Name: Morné de Jager
Cell: 082 565 4059
E-mail: morne@menco.co.za
Date: 19 March 2019
Ref: Gunstfontein WEF change

SPECIALIST STUDY: NOISE IMPACT ASSESSMENT: PROPOSED GUNSTFONTEIN WIND ENERGY FACILITY: CHANGE OF WIND TURBINE LAYOUT

Figure 1: New locations of wind turbines compared with old layout.

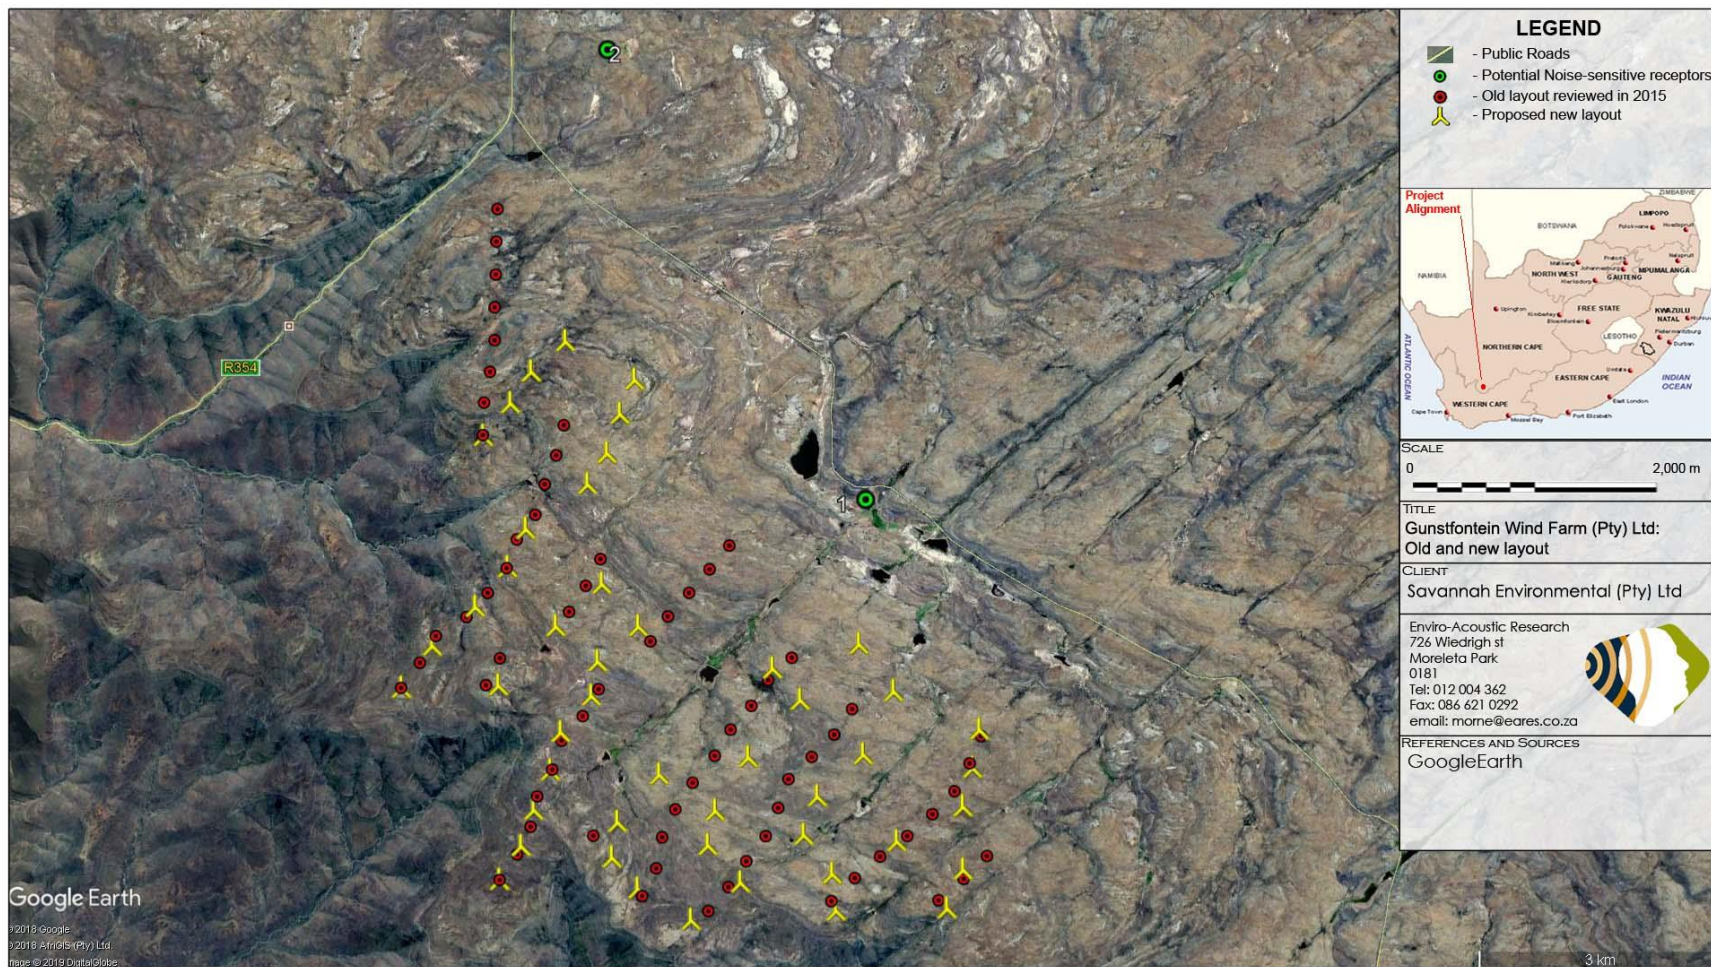
The developer of the Gunstfontein Wind Farm has since optimized the layout of the wind farm, designing the wind turbines at optimal locations (see **Figure 1**). The change however does not move any wind turbines closer than 1,000 m from any potential NSDs, with the closest wind turbine located more than 1,700 m from the closest NSD. Considering the location of the wind turbines and the potential noise impact, it is my opinion that the change will not increase the significance of the noise impact.

A full noise impact assessment with new modeling will not be required and the recommendations as contained in the previous document will still be valid. This recommendation is based on the outcome of the report which indicated that the extent of the potential impact is limited to 1,000m from the closest wind turbines (Section 8.3, pg. 85). The impacts, the significance, findings and the recommendations of the noise report (report SE-GWF/ENIA/201512-Rev 0) will remain the same, and it will not be required to do any additional or other acoustic studies for the proposed changes.
